SUBJECT: Transmittal of Revised Responses to AP1000 DSER Open Items

AP1000 Design Certification Review
Draft Safety Evaluation Report Open Item Non-Proprietary Responses

DSER Open Item Number: 3.6.3.4-2 Addendum 1 Revision 2

Figure 9 – Isometric View: Comparison of AP600 and AP1000 DVI-A Piping System

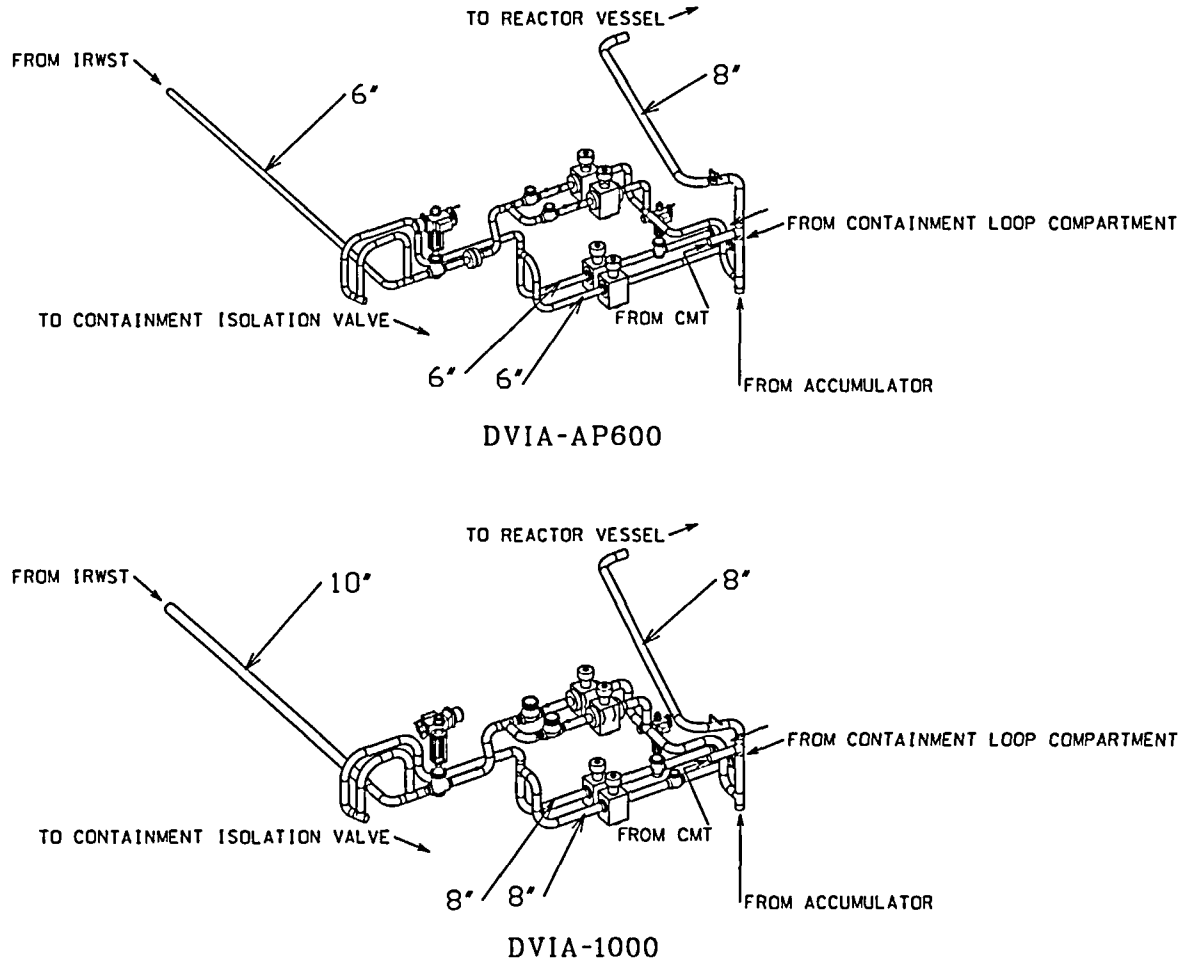
Complexity of piping system - The DVI-A piping system is complex, and was particularly challenging to qualify for the AP600. TheAP600 design and analysis of the DVI-A subsystem was performed over several iterations that included perturbations in the piping layout, support configuration, and piping analysis. Figure 9 shows isometric views of both the AP600 and AP1000 DVI-A piping system.

Figure 10 - Bounding Analysis Curve – DVI-A – 8" (316 SS, 537 °F)

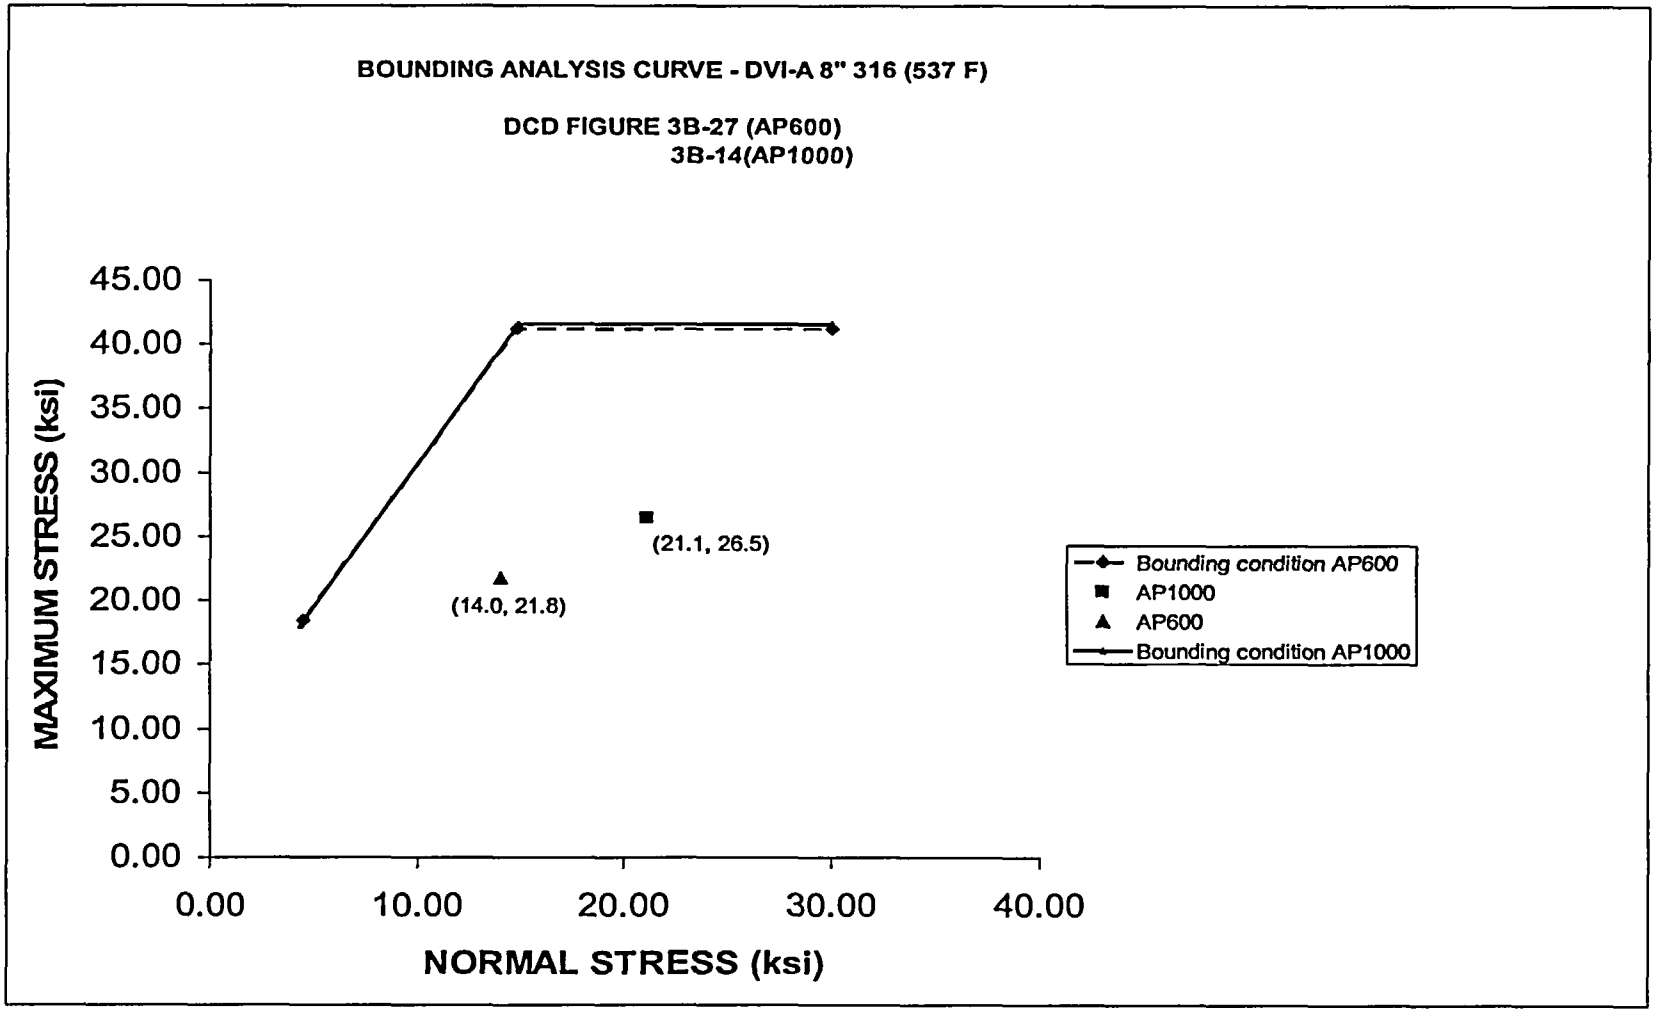
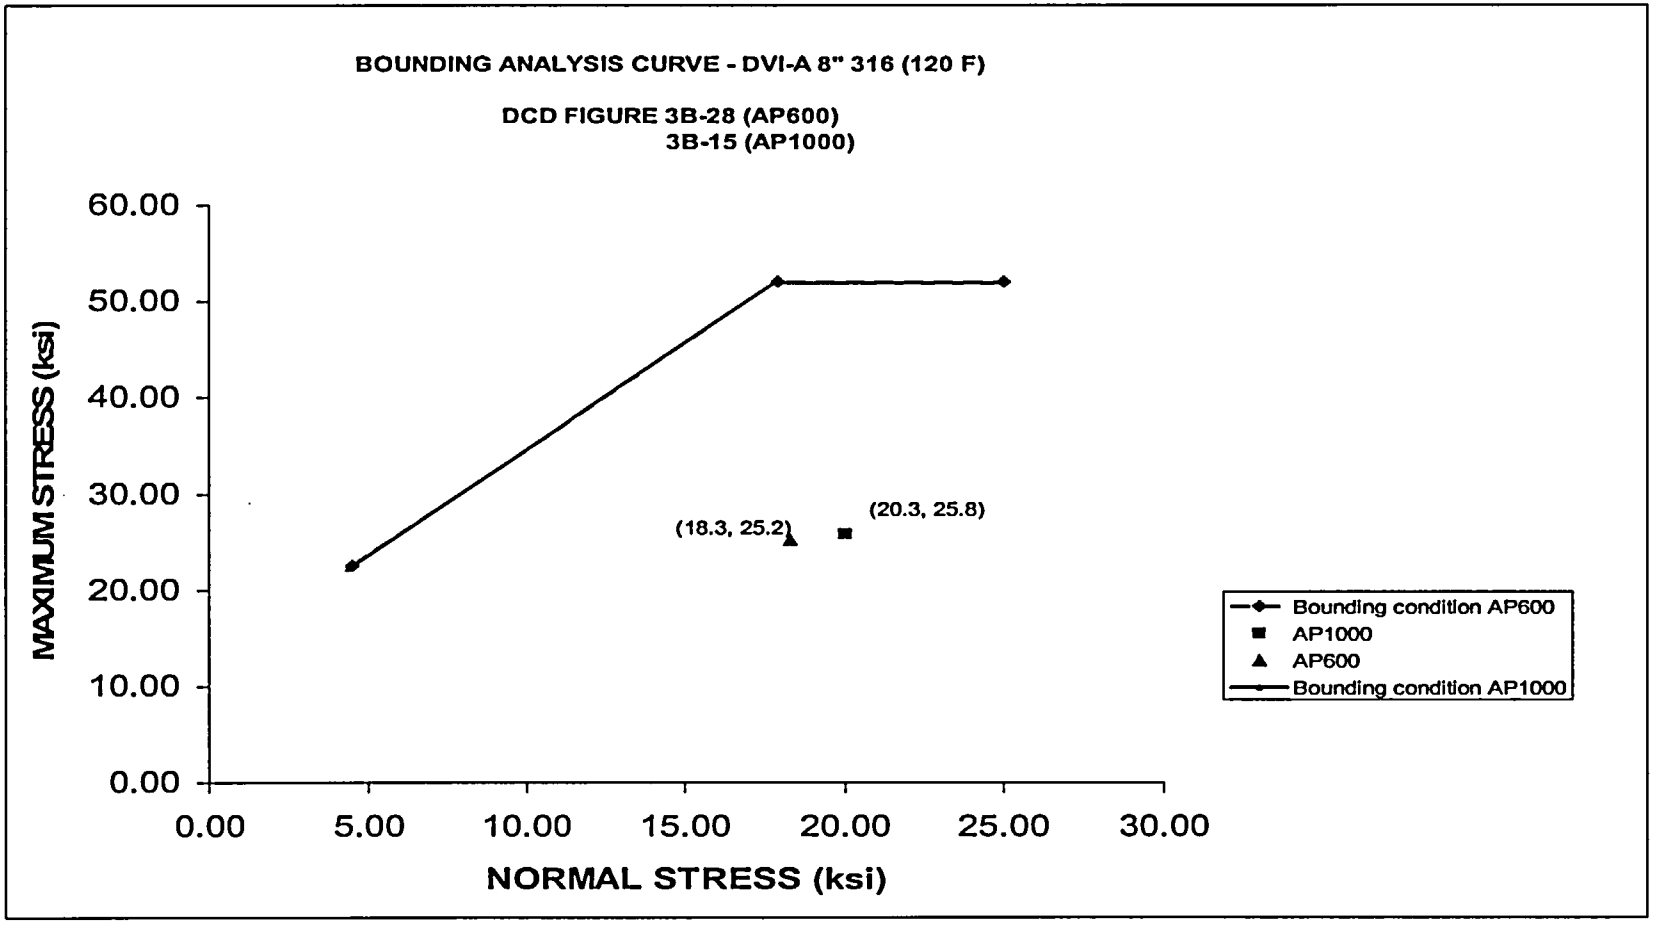
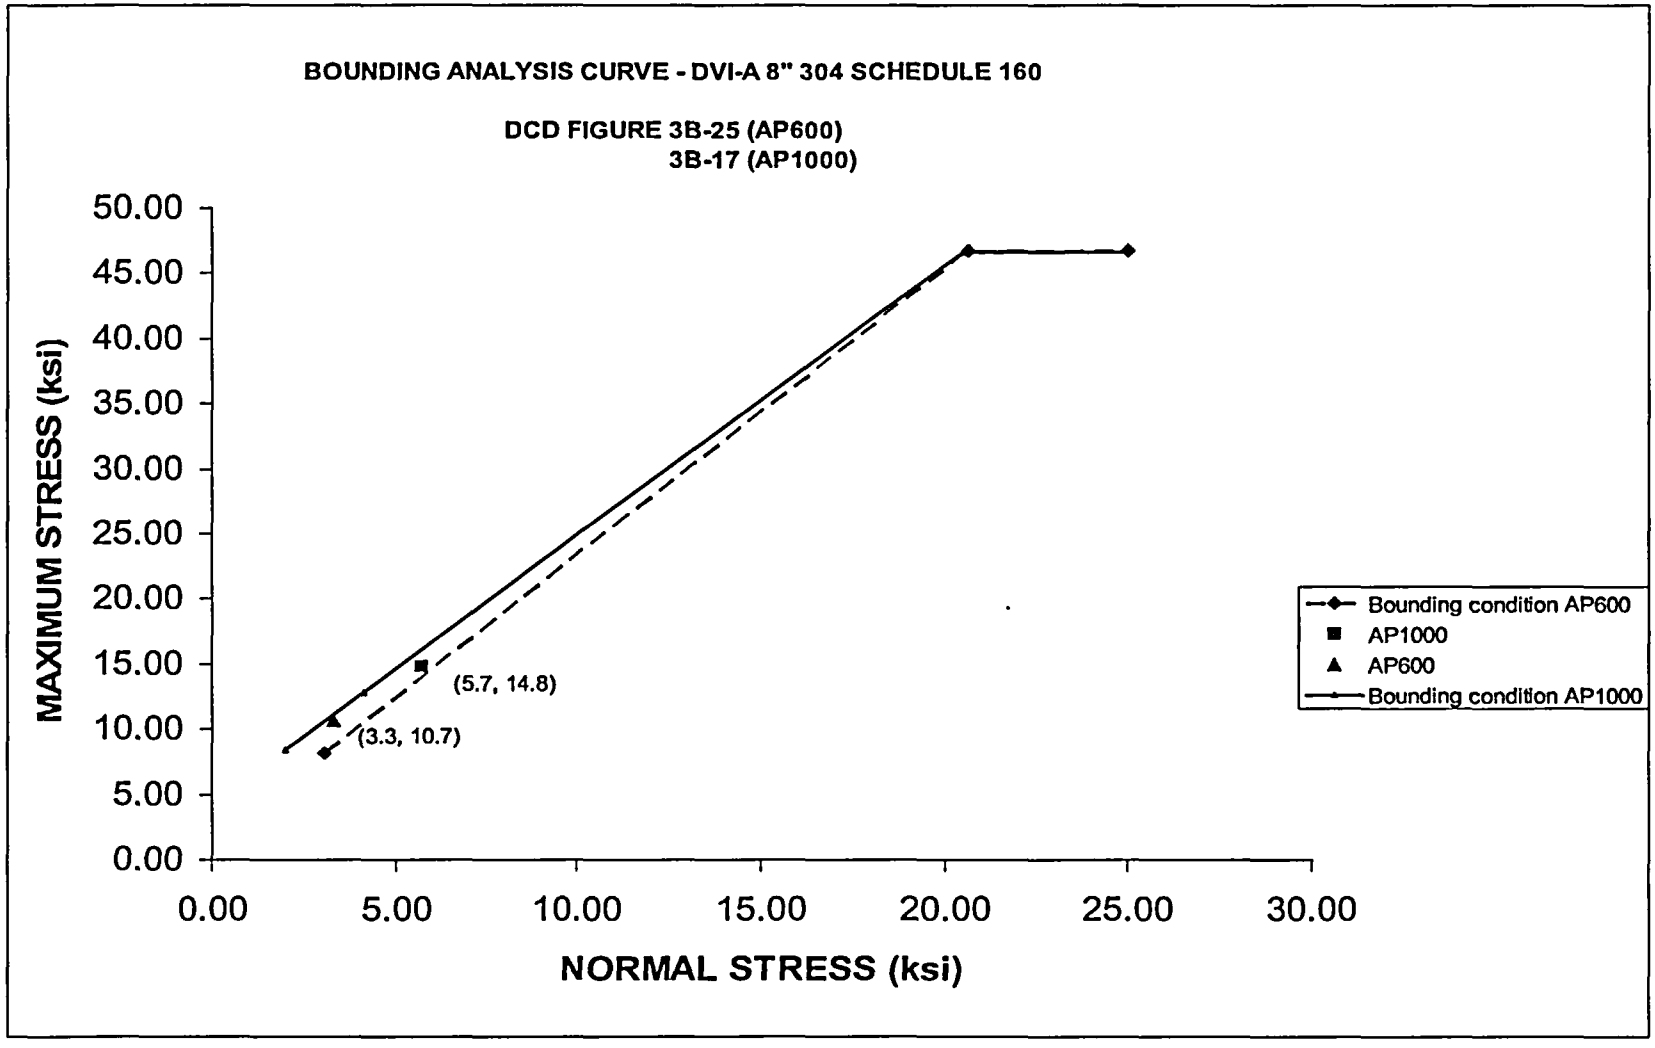
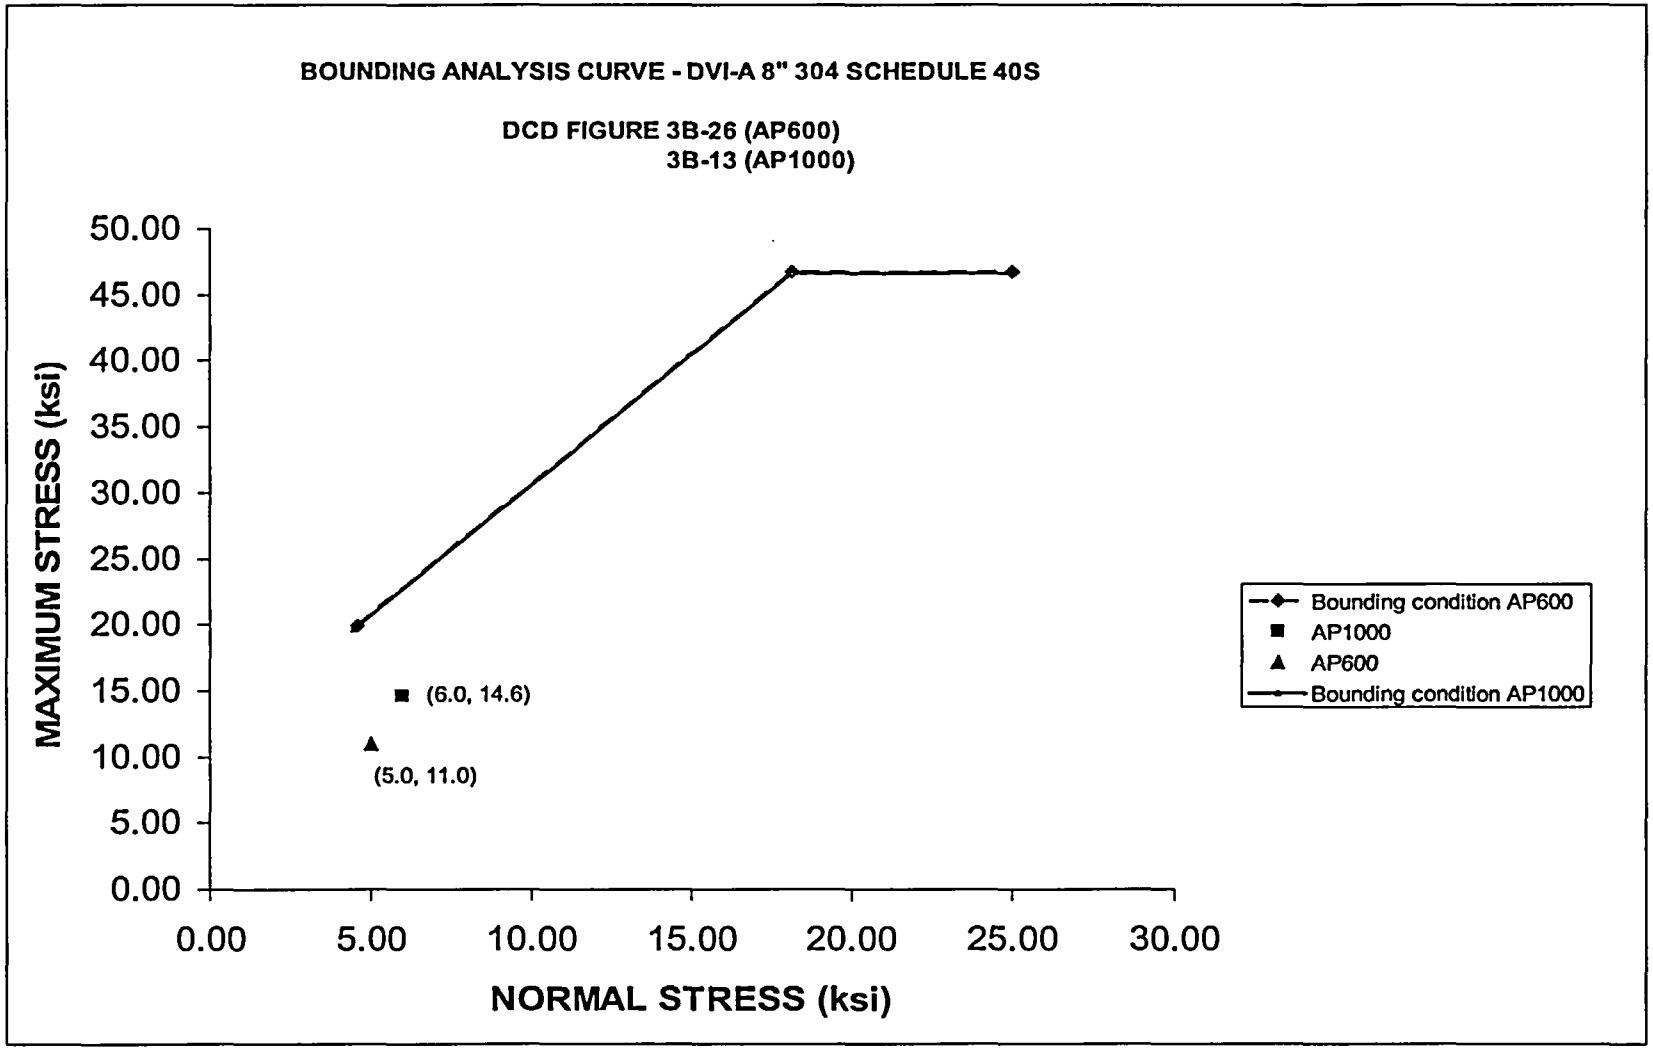
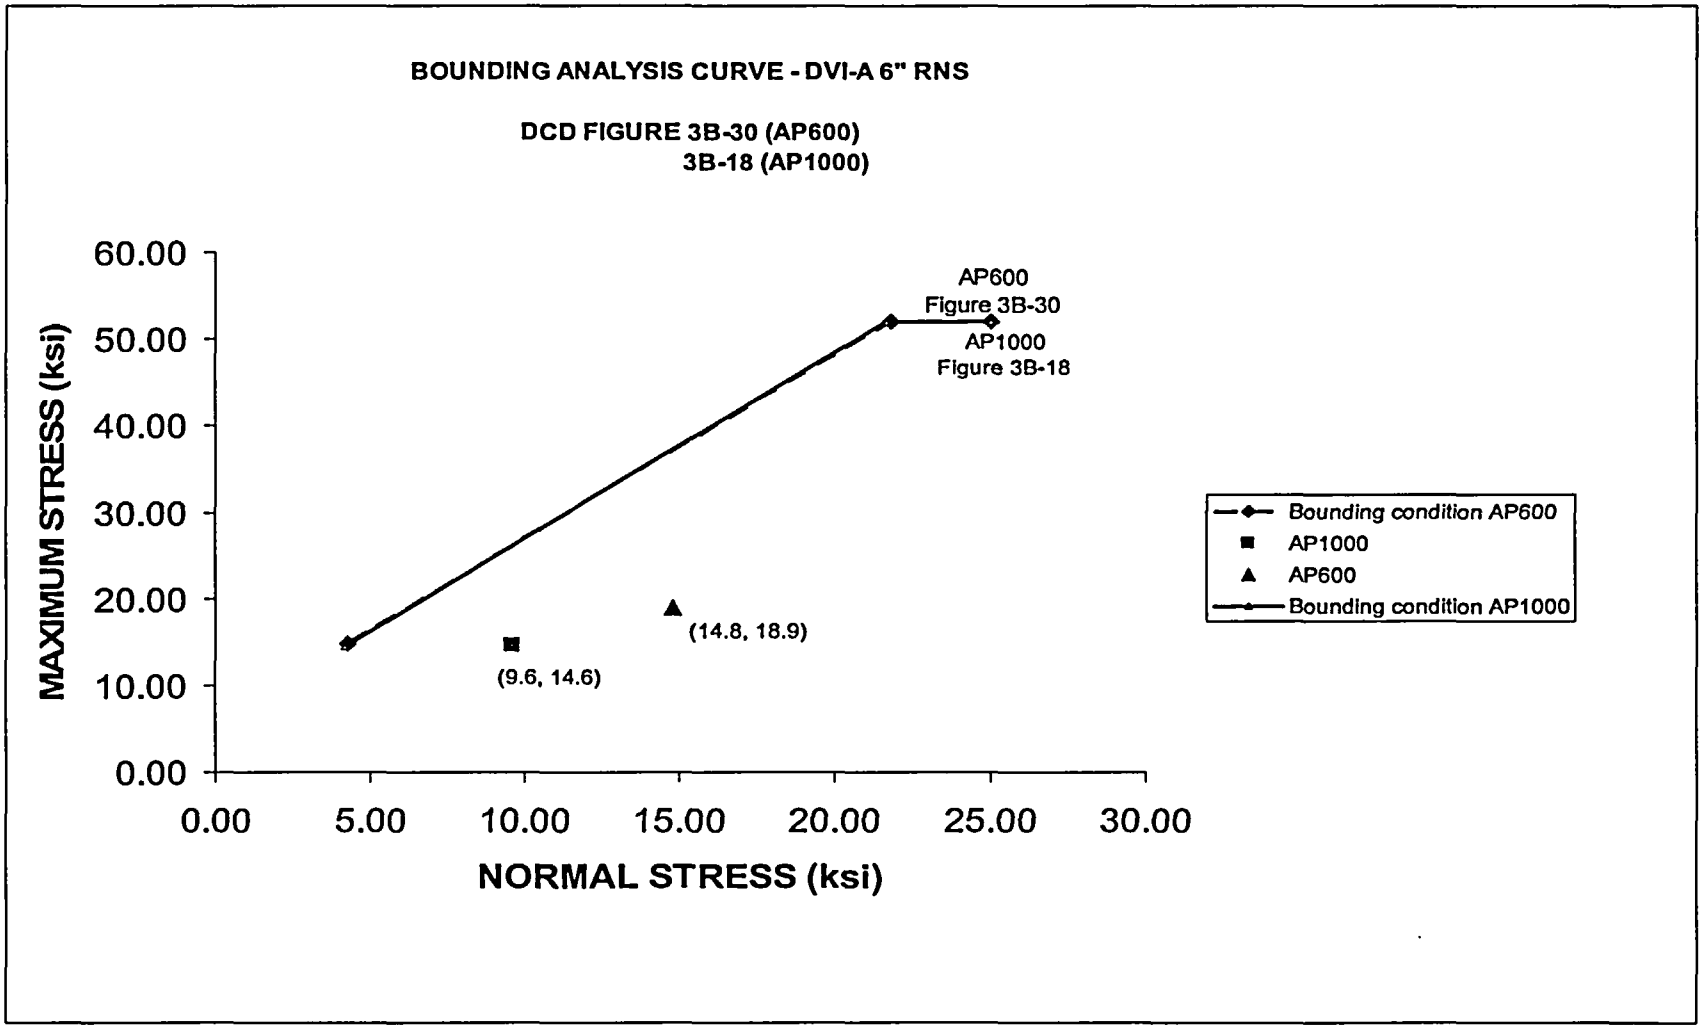
Revision 2 of this response provides discussion and results of revised DVI-A piping analysis in Section 2.5 and Figures 10-15 of this addendum.

Pipe Segment	Maximum Calculated Stress (ksi)	Bounding Analysis Curve Limit (ksi)	Report Figure
8-inch, 316SS, 537F	26.5~~23.9~~	41.6	Fig. 10
8-inch, 316SS, 120F	25.8~~22.0~~	51.9~~44.0~~	Fig. 11
8-inch, 304	14.8~~13.8~~	16.2~~14.4~~	Fig. 12
8-inch, Sch 40S	14.6~~11.7~~	22.7	Fig. 13
6-inch, RNS	14.6~~14.5~~	26.1~~22.9~~	Fig. 14
8-inch, PXS	26.5~~22.3~~	45.4~~44.5~~	Fig. 15
